**In the Matter of Proposed Plan Change 1 to the
Partially Operative Dunedin City Second Generation District Plan (2GP)**

Planning Evidence of Darryl Sycamore

APPENDIX 1 – FIRE FIGHTING PROVISIONS

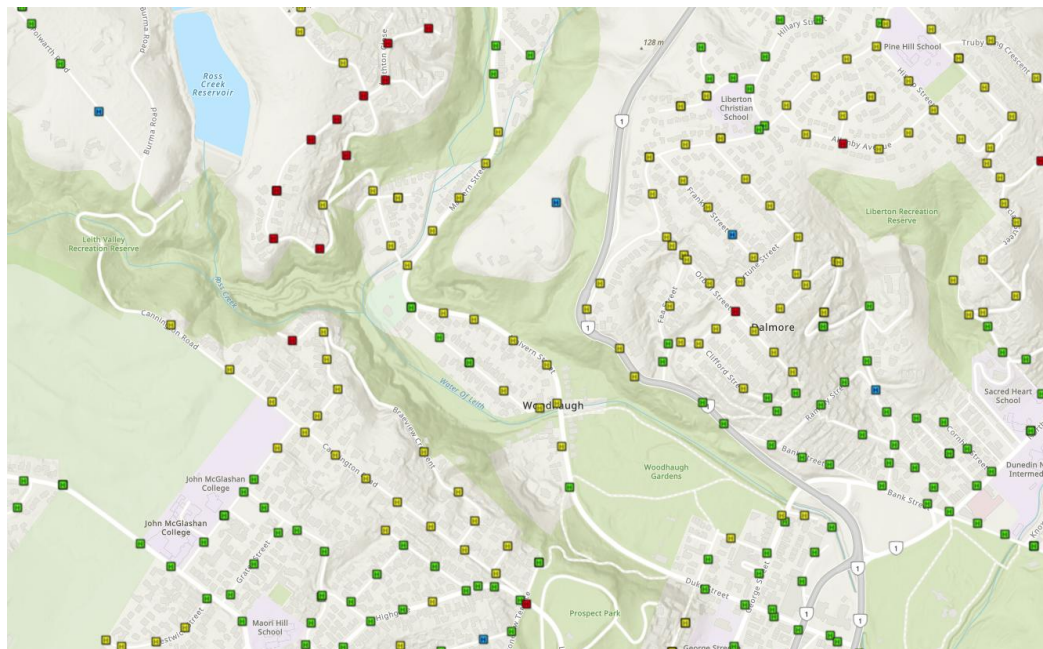
17. Following notification of Plan Change 1 and observing the specific conditions relating to providing suitable water pressure (12.5L/sec for each of two hydrants) it become clear why no response from Council has been forthcoming despite numerous requests. In short, a large percentage of existing properties and or development in the City is not compliant with the requirements of the Fire-fighting Code. This is illustrated in Appendix 1.

26. As an example Appendix 1 shows the properties along Helensburgh Road near Wakari Hospital as all being <10 L/sec flow, with some only 4L/sec or 5L/sec. A single fire appliance would struggle to utilise that flow, let alone two compliant hydrants as required in the Code.

27. Looking wider across the City, the FENZ GIS shows much of Maori Hill (i.e. Preswick Street, Cannington Road, Cairnhill Street or Braeview) having individual hydrants ranging from 10L/sec to 15L/sec. None of these properties can comply with the proposed rule in relation to the provision of adequate pressure.

30. It is my opinion this rule should be deleted given the structural failure of the Cities water network not being able to provide sufficient water to meet the Code. Council should focus on improving the pressure of the mains network and then re-introduce this rule when landowners are not forced to apply alternative options or seek consent that result in a series of unintended perverse outcomes.

APPENDIX 3 – STORMWATER OPEN WATERCOURSE EXAMPLES

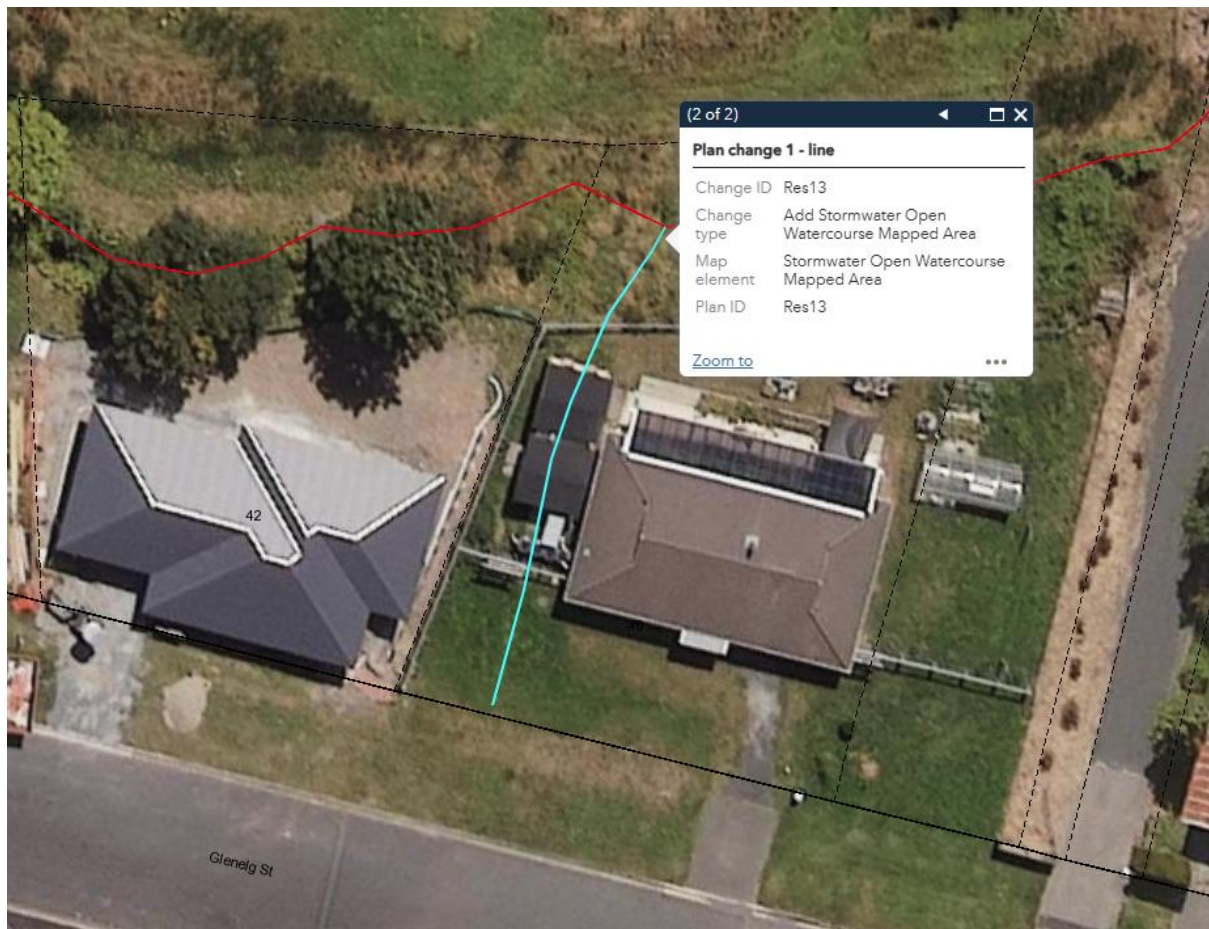
- are simply a flat landscaped lawn, or
 - is located inside forest or dense hedging.
33. For some landowners, a mapped Stormwater Open Watercourse on an adjoining property will sterilise the ability to use their own land unless they seek a consent (at their cost). This is shown in my submission in relation to the proposed Stormwater Open Watercourse at the rear of 62 Queen Street, Dunedin. Here a Stormwater Open Watercourse has been mapped through a dense hedge at Cosy Dell Tennis Club, and will impact the ability to use the land 2.5m inside the Queen Street property, which is zoned ICR. The yard setback for this zone is only 1.0m.

36. A landowner can incorporate these exempted structures into their back yard where a Stormwater Open Watercourse may be mapped, but they cannot erect a deck off their house if it is closer than 5m from either side of the mapped watercourse. This is, of course, absurd.

43. In my opinion the proposed Stormwater Open Watercourse provisions are poorly considered and should be rejected by the Panel. The severity of the provision is simply far too great to impose on private landowners.
